12.6.4 Ambient air quality (elevated receivers)

BL_EIS_CH10_M002_ConstructionAssessment_V8

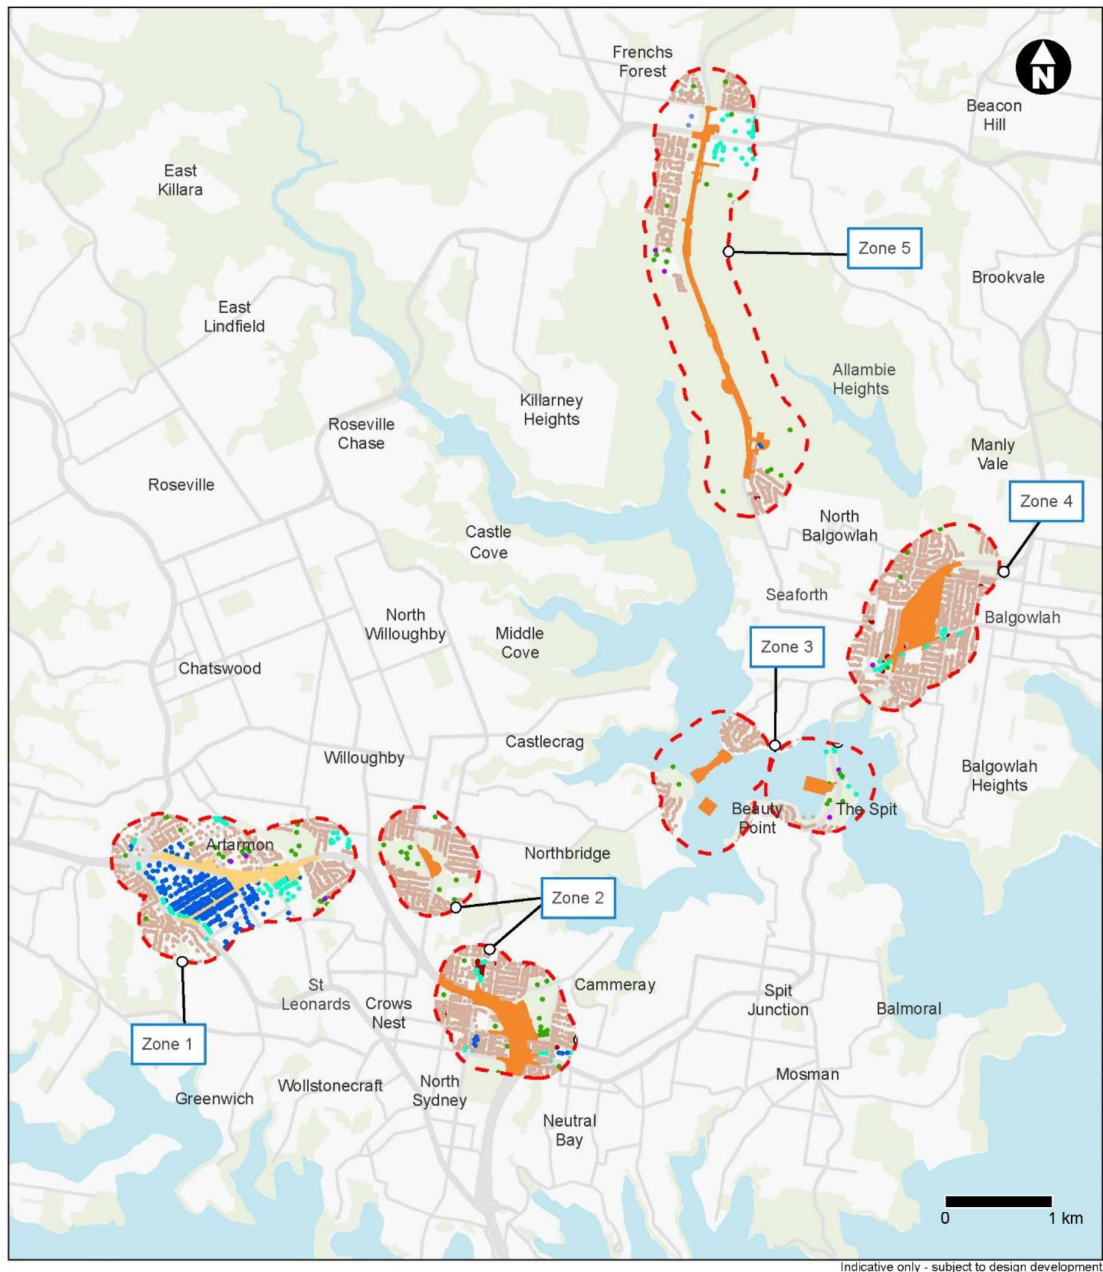
There does not seem to be a detailed review based on the topography of the area. Between the Burnt Creek at the end of Dudley street and Sydney Road there is a 28 metres difference and for the high school it is 37 metres. If the ventilation stack and toll facilities is situated over the tunnel entry / exit then the difference is reduce substantially ie to 21 metres. Hence the reference to restricting "habitable structures above 20 metres and within 300 metres of a ventilation outlet" is questionable for the the proposed Burnt Creek entry exit ventilation stack.

Hence move ventilation stack from BGC and have it above tunnel exit or on land parallel in Dudley street. If the Government is spending 60 million dollars to acquire houses in Dudley Street then this is where the Ventilation stacks and motorway facilities should be located
